# UNITED STATES PATENT AND TRADEMARK OFFICE

APPLICATION NO.	FILING DATE	FIRST NAMED INVENTOR	ATTORNEY DOCKET NO.	CONFIRMATION NO.
10/693,981	10/28/2003	Masashige Tamura	03500.017673	3977

# Office Action Summary

## DETAILED ACTION

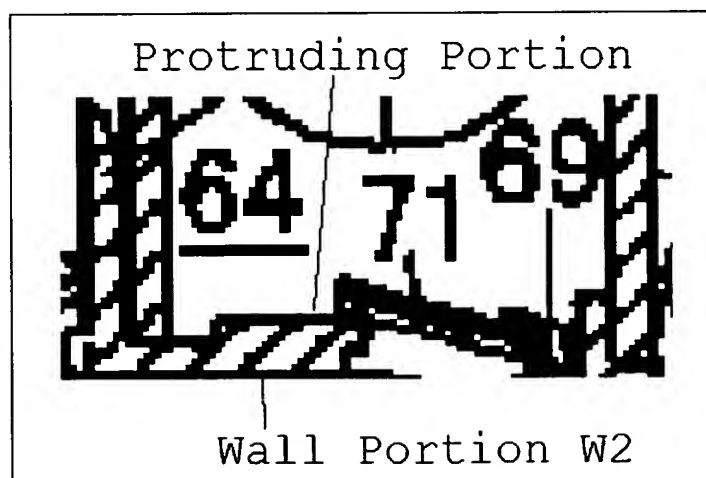
Notani et al. disclose an image forming apparatus in figure 27 including: a developing device (Dm) containing developer including toner and carrier, the developing device (Dm) having a first chamber (62) for developing an electrostatic image formed on an image bearing member (16), and a second chamber (64) constituting a developer circulating route between the second chamber and the first chamber, as shown by figure 7.

A developer carrying member (R1) is provided in the first chamber (62), and an agitating and carrying member (R2) including a spiral vane (R2b) is rotatably provided in the second chamber (64) for carrying the developer, and a rotary member (H) holds the developing device (Dm) and is rotatable in a route including a developing position. Supplying means (R0) is for supplying the developer to the developing device, which is in the developing position.

Shutter (71) is a valve mechanism for opening and closing the opening (67a) by operation of gravity of the valve mechanism with the rotation of the rotary member.

Developer exhaust port (67a), or alternatively end connection (74), is an opening provided in the second chamber (64) for outwardly discharging therethrough any excess developer resulting from the supply of the develop.

A portion of developing device (Dm) from figure 27 is shown below. Upper wall (W2) is a wall portion provided in the second chamber opposite to a space created by an opening of the opening and closing member (71) near the opening and closing member (71) on a side of opening and closing member (71) and protruding toward an inside of the second chamber (64).

Alternatively, there is another wall portion (shown directly below the numeral 9 in the figure, which is provided in the second chamber opposite to a space created by an opening of the opening and closing member (71) near the opening and closing member (71) on a side of opening and closing member (71) and protruding toward an inside of the second chamber (64).
